CITY PLAN COMMISSION STAFF REPORT

Project Name
Harlem Flex Development Plan

Request
CD-CPC-2022-00111
Development Plan (Non-Residential)

Location 300 N Grand Ave
Area About 0.6 acres
Zoning B3-2
Council District 4th
County Clay
School District North Kansas City

SITE PLAN
 SHEET NO. **C1**

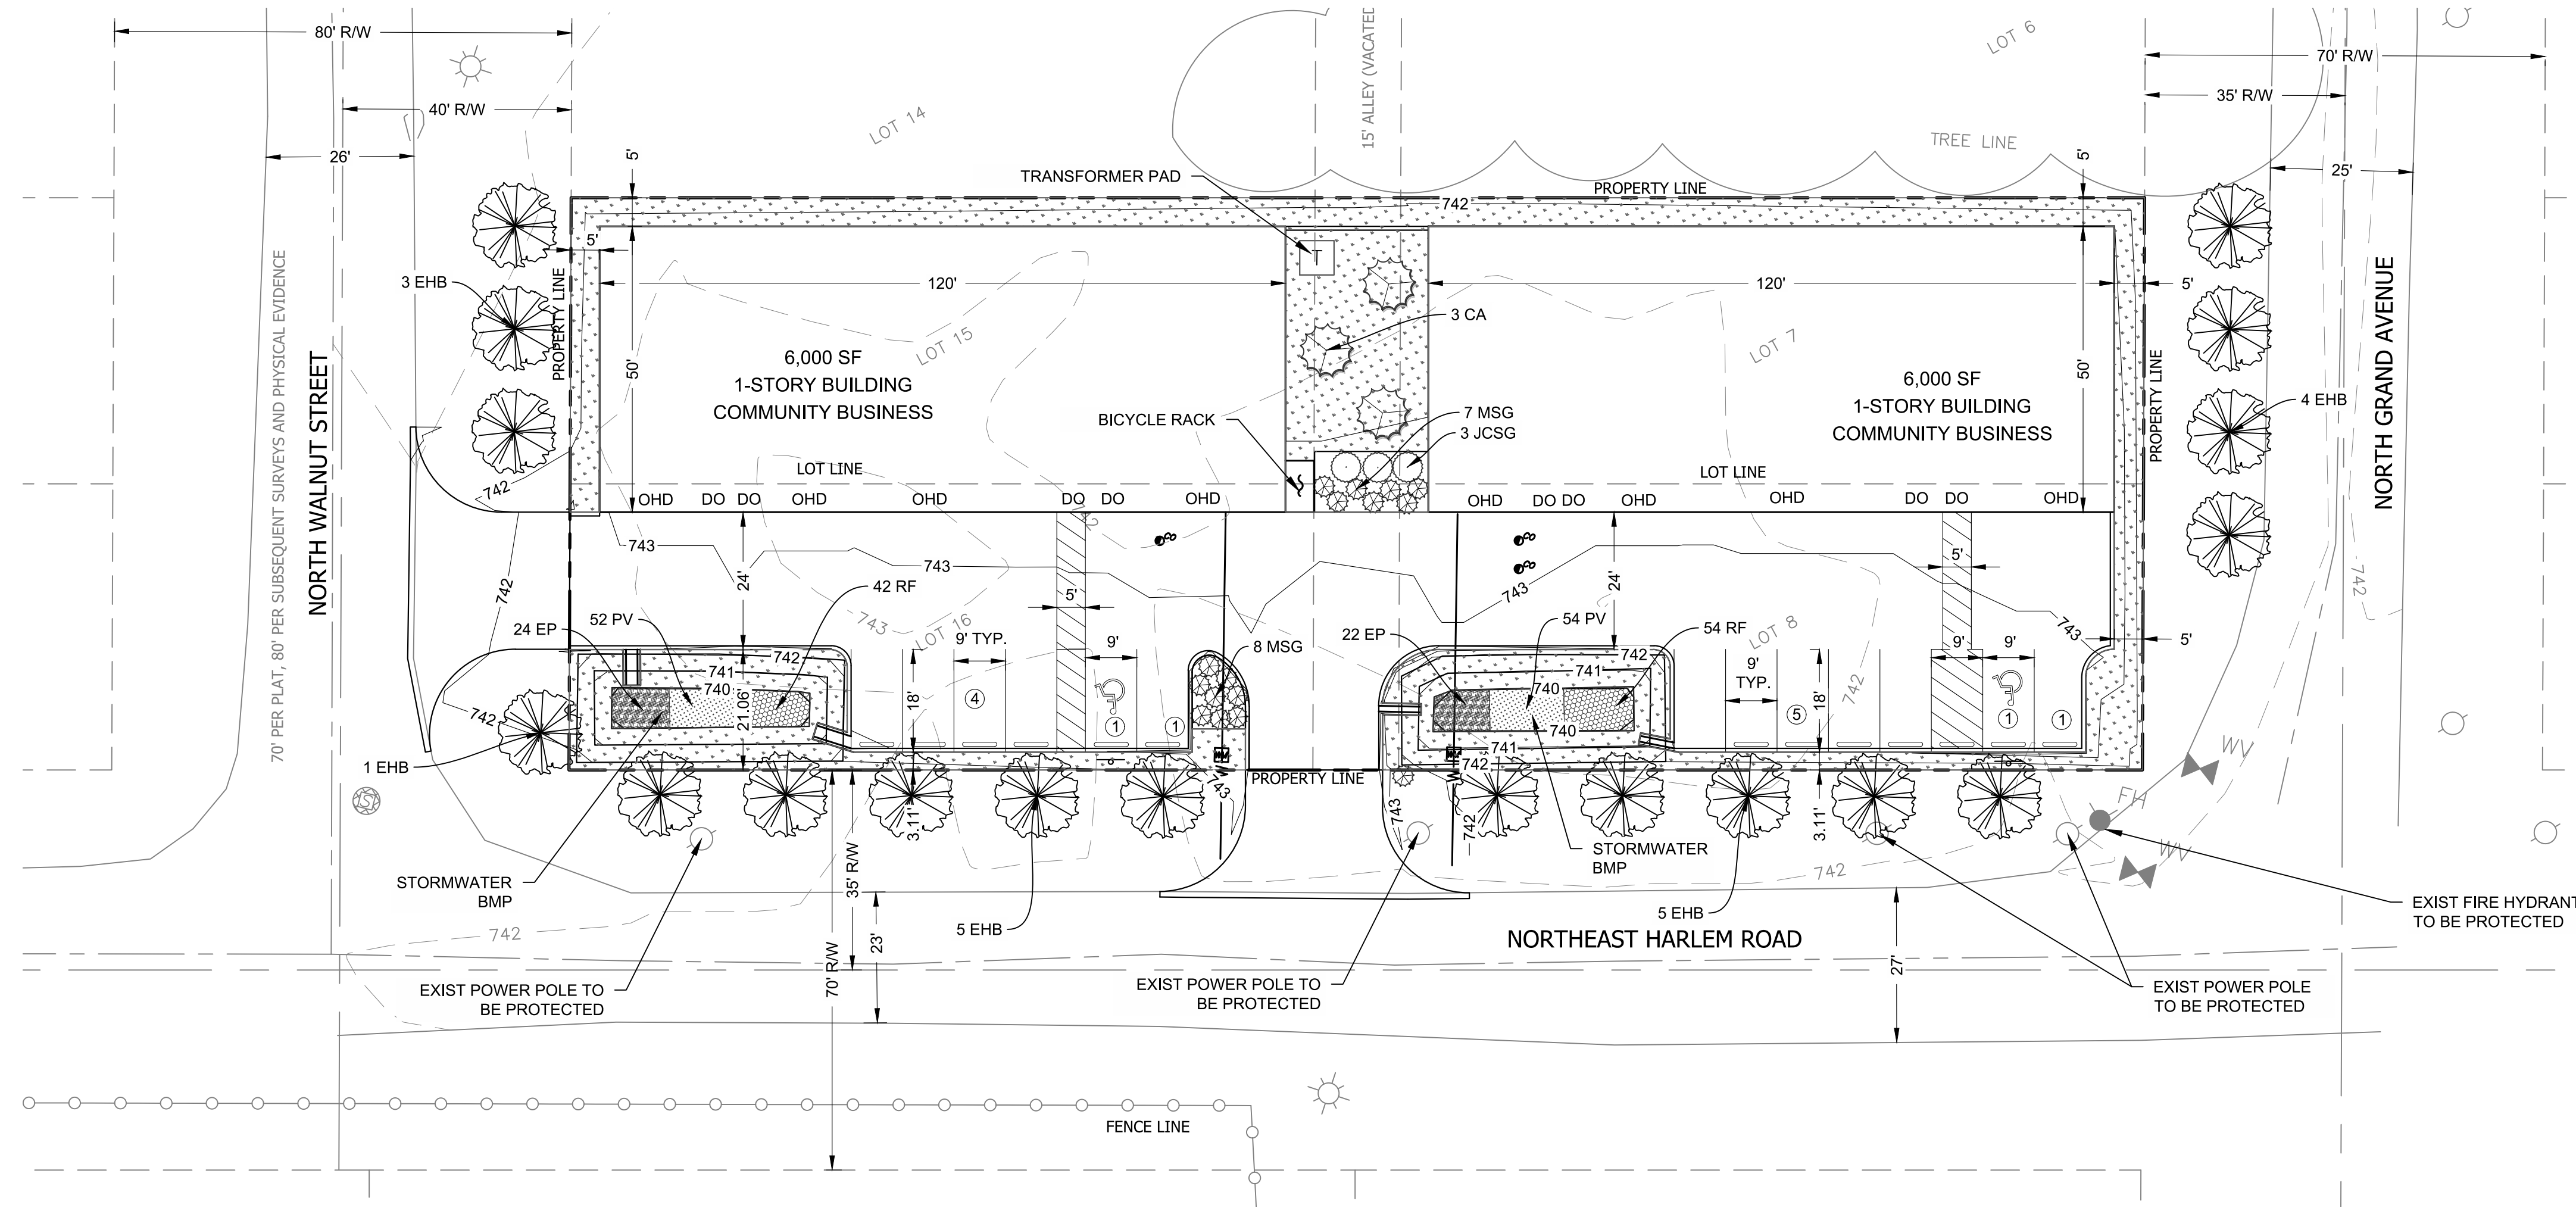
- Deviation for Rear Yard Setback (Required 25 ft- Provided 5 ft)
- Deviation for Side Yard Setback on Corner Lot (Required 15 ft- Provided 5 ft)
- Deviation for distance for driveway to intersection
- Waiver of Half Street Improvements
